Town of Easton
1060 Easton Valley Road
Easton, NH 03580

July 18, 2016

the Army Corps of Engineers is soliciting comments on the proposed Northern Pass (Eversource & Hydro-Quebec) transmission project. The Easton Conservation Commission submits the following:

Ham Branch Gale River and Vicinity Easton area, New Hampshire

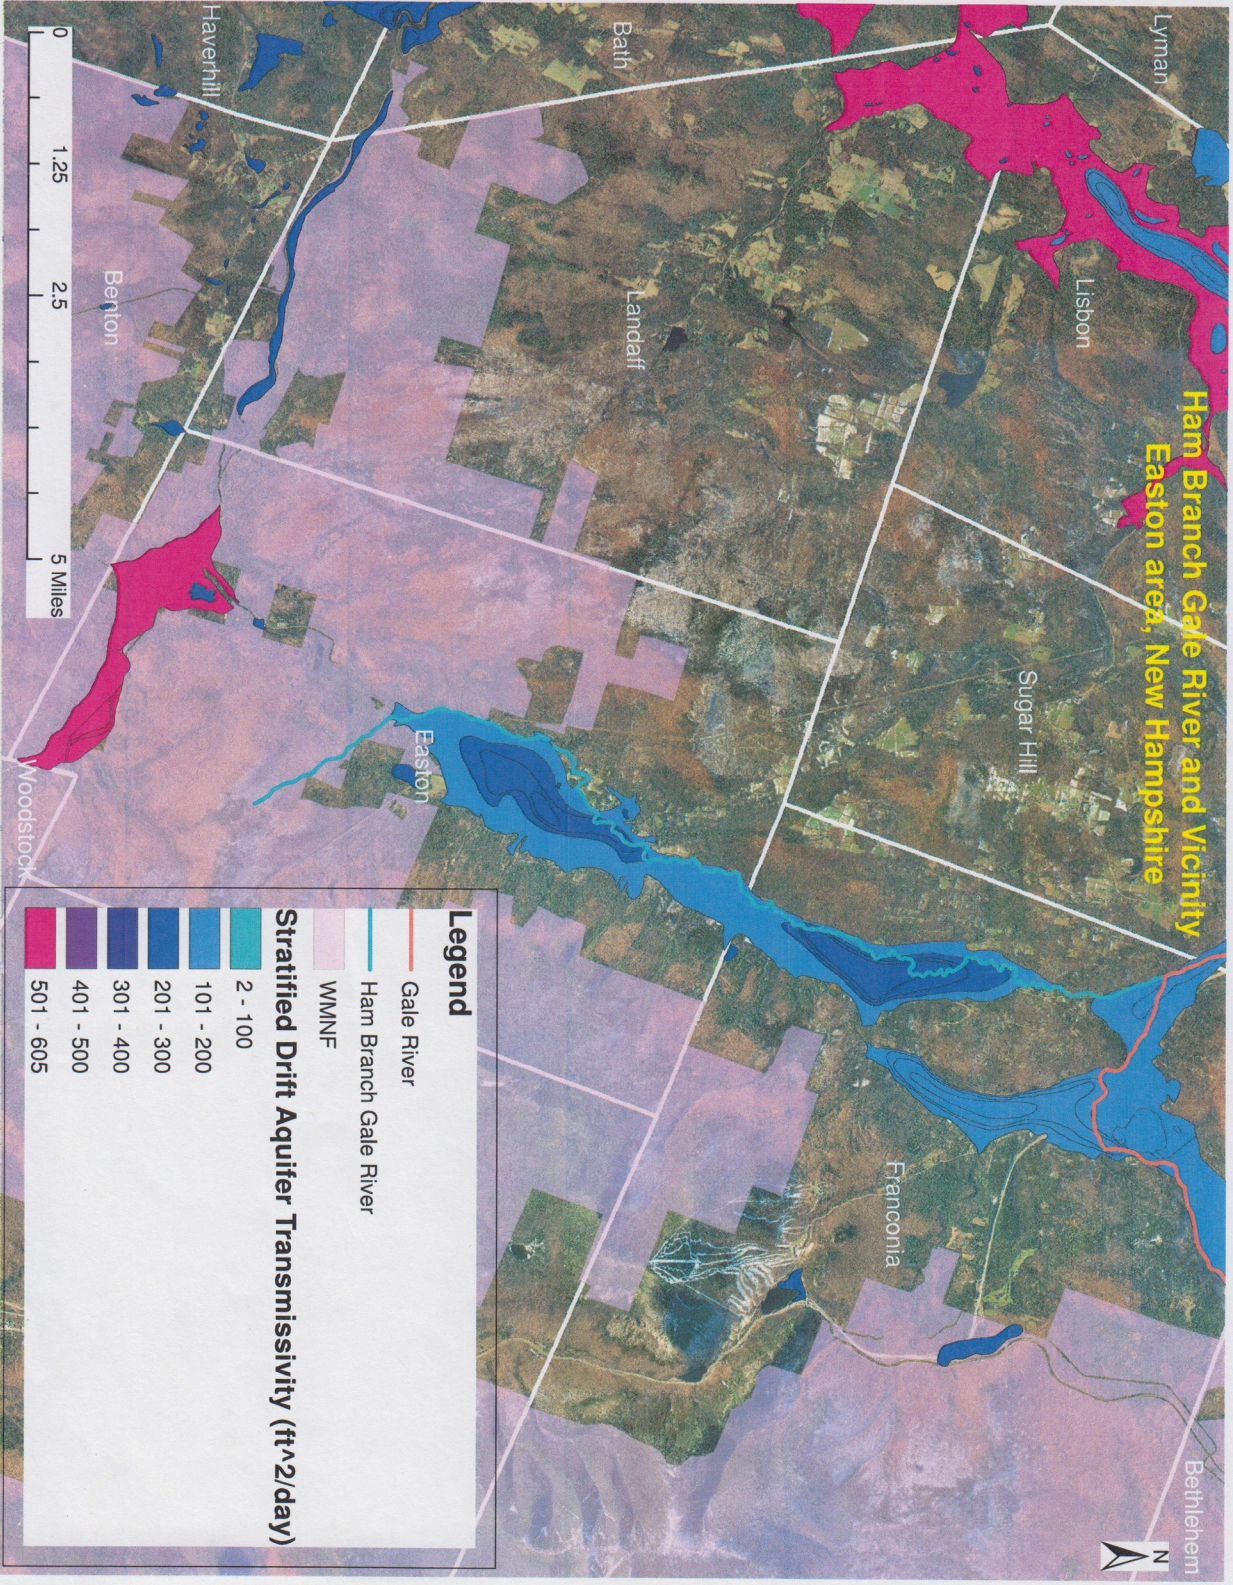
The application also fails to address the aquifers that underlie a significant portion of the proposed burial route in Easton. It states: "Groundwater table depth within the Project area is typically 10–20 feet below the land surface, but does range from a few feet to several hundred feet deep. The water table fluctuation mirrors that of annual stream flow data with a high occurring in the spring and a low occurring in the late summer/early fall." They fail to explain how the HDD at up to 65' below the land surface will affect groundwater and aquifers, and how HDD will occur in the aquifer protection districts that exist in many towns, including Easton. The general reference to best management practices for aquifer protection is inadequate and only addresses above-ground practices.
